Figure 1. Recall Caliper Kits

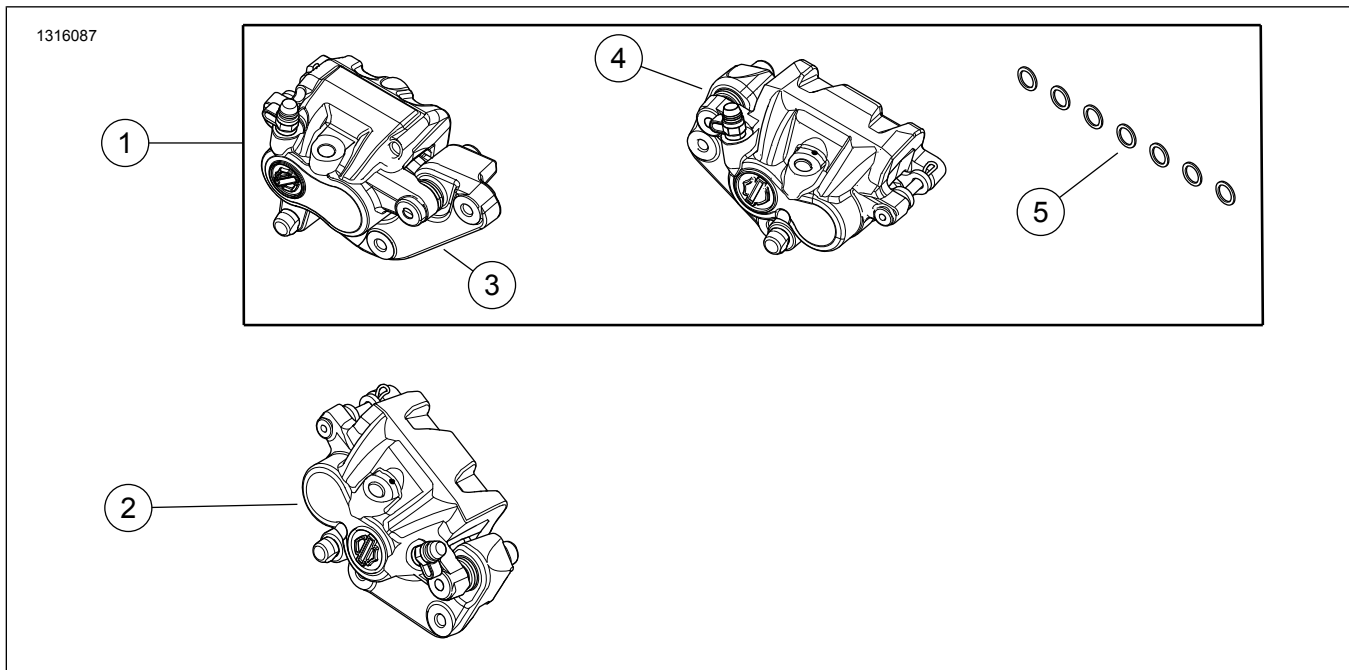
2. Replace the calipers by following the service manual for the year and model of the vehicle this bulletin is being applied to.

Models	Item	Kit	Kit Items	Qty	Description	Part No.
500, 750, 750A	1	91500097	3	1	Left front caliper	41300158A
			4	1	Rear caliper	41300159A
			5	7	Banjo washers ⁽¹⁾	12300033
750A ⁽²⁾	2	91500098	2	1	Right front caliper	41300190A

(1) Installing kit 91500097 uses four washers, installing kit 91500098 uses three washers. There will be three extra washers after installation of kit 91500097 only.

(2) Both kits 91500097 & 91500098 must be installed on 750A models.
